Planning Commission Staff Report

Project Type: Sign Package

Meeting Date: February 11, 2019

Description: **Forty West Office Building, Sign Package:** A request for a Sign Package for a 3.625 acre tract of land located on the north side of North Outer 40 Road approximately 1,300 feet west of its intersection with Timberlake Manor Parkway.

Figure 4: Existing and Proposed Monument Sign Conditions

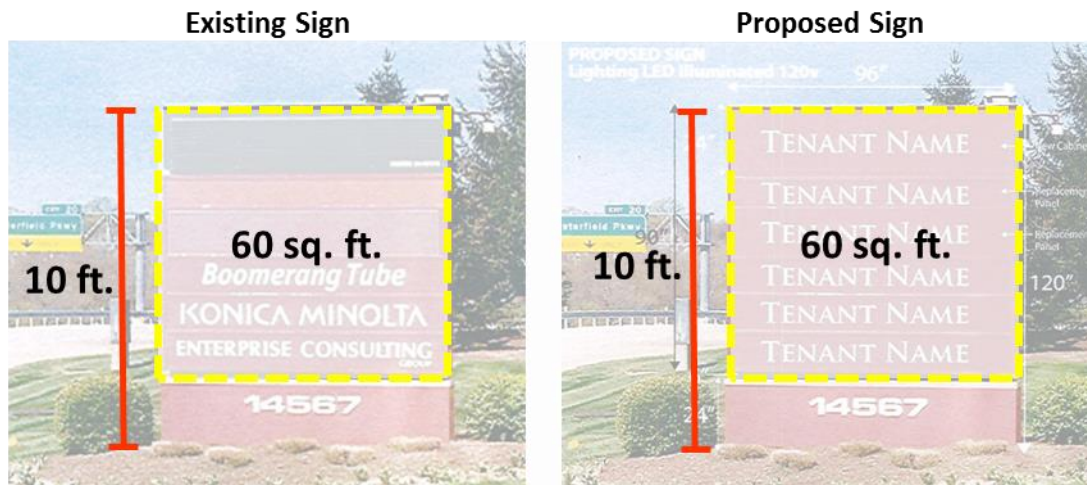
Sign A - Freestanding Monument Sign – This sign is located along the property’s frontage of North Outer 40 Road and currently serves the office tenants located within this development. These tenants are served by a common entrance, and the UDC only permits individual signage for tenant spaces that have independent entrances. The applicant is proposing to remove the top electronic message portion of the existing sign and replace this portion with an aluminum cabinet consistent with the size and style of the existing panels identifying individual tenants. The applicant is also proposing to replace the existing panels to provide a more cohesive look among the tenant names. The existing size of the monument sign will remain unchanged with an overall height of ten (10) feet and sign face outline area of 60 square feet. The existing sign is not currently illuminated and the applicant is proposing to install internal low voltage LED lighting. The existing and proposed conditions of the monument sign are depicted in Figure 4 below.

Modifications to the existing monument sign include removal of the electronic message center on the top portion of the sign and replace with a sign panel to serve as tenant identification to match the remainder of the sign. The applicant has also indicated in the narrative statement submitted that all panels on the sign cabinet will be replaced in order to establish a cohesive style among the tenant identification, and internal LED illumination will be added as none currently exist.

The site specific ordinance for this development permits one (1) monument sign not to exceed ten (10) feet in height and 75 square feet in outline area to be landscaped around its base. The overall size of the sign will remain unchanged and existing landscaping will be maintained in accordance with this regulation. Table 1 to the right details the permitted and proposed elements for a monument sign at this location.

Figure 5: Overview of Sign Package Requests

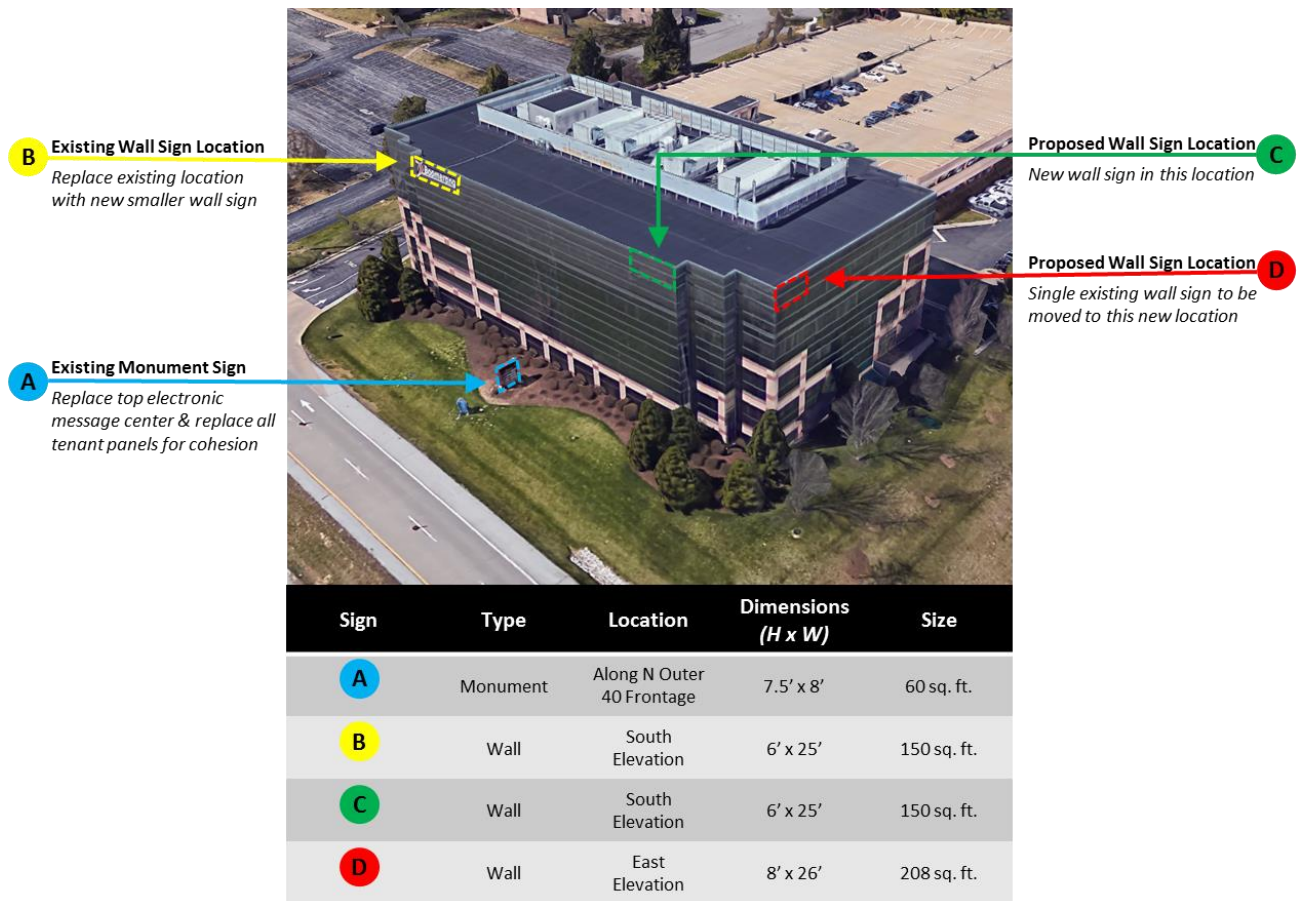
Sign B - Attached Wall Sign (West Corner of South Elevation) – This attached wall sign location is on the western end of the south elevation facing North Outer 40 Road and I-64/US-40. Currently, this location has the only attached wall sign permitted for this development, which is 208 square feet in outline area. This existing sign is proposed to be relocated to the east elevation (Sign “D”) and replaced with a 150 square foot attached wall sign in its place.

Sign C - Attached Wall Sign (East Corner of South Elevation) – This attached wall sign location is opposite Sign “B” on the eastern end of the south elevation of the building. There are no current signs in this location, and a 150 square foot attached wall sign is proposed for this location to match the size and dimensional regulations proposed for “Sign B” noted above.

Sign D - Attached Wall Sign (South Corner of East Elevation) – This attached wall sign location is on the southern end of the east elevation of the building and is also visible from North Outer 40 Road and I-64/US-40 though there is no roadway frontage. The existing sign on the south elevation is proposed to relocate to this location and has a total of 208 square feet.

Three attached wall signs are also proposed as part of this Sign Package request to be visible from North Outer 40 Road and the I-64/US-40 corridor. Currently, there is one attached wall sign located on the west side of the south elevation with a total of 208 square feet. Permitted wall signage for the Forty West Office Building development is currently governed by the sign regulations of the Unified Development Code (UDC) as described below:

The size of the attached wall signs permitted on roadway frontage utilizing the five percent (5%) measurement exceed the 300 square foot maximum limit on both the south and north elevation. Each sign shall not be larger than 300 square feet, producing a total of 600 square feet of wall signage permitted on the building. The request is for a total of 508 square feet of wall signage to be dispersed among the south and east elevations; 300 square feet of which is proposed to be equally divided for two wall signs on the south elevation, and the remaining 208 square feet is proposed for the east elevation as a relocation of the existing wall sign. Table 2 above details the permitted and proposed elements for wall signs at this location.
